RE: **Jefferson Hotel**  
**Restaurant Ln NE**  
**Grading Plan Stamp Date: 7/30/18**  
**Drainage Report Stamp Date: 7/30/18**  
**Drainage File: F17D044C**

Based on the submittal received on 7/31/18, the grading plan and drainage report cannot be approved for building permit until the following are corrected:

RE: **Jefferson Hotel**  
**Restaurant Ln NE**  
**Conceptual Grading Plan Stamp Date: 4/13/18**  
**Drainage Report Stamp Date: 4/17/18**  
**Drainage File: F17D044C**

ENGINEER'S SEAL	JEFFERSON HOTEL	GRADING AND DRAINAGE PLAN		7/26/2018 7/26/2018	DRAWING BY: JCM/ML DATE 7-30-18 SHEET # C1 JCM 2/18/82
-----------------	--------------------	------------------------------	---	------------------------	---

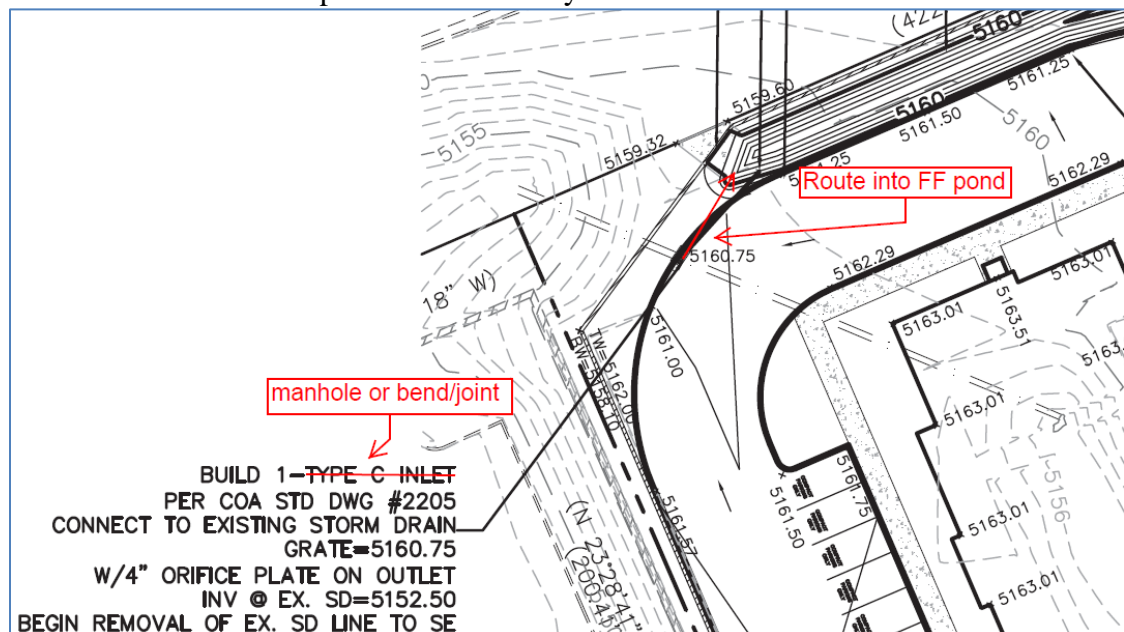
1. The Type C inlet at the NW corner should be removed as it allows surface flows to bypass the first flush pond. Stormwater draining to this low spot will need to be routed to the pond first. Also the 4" orifice plate isn't necessary on this outlet:
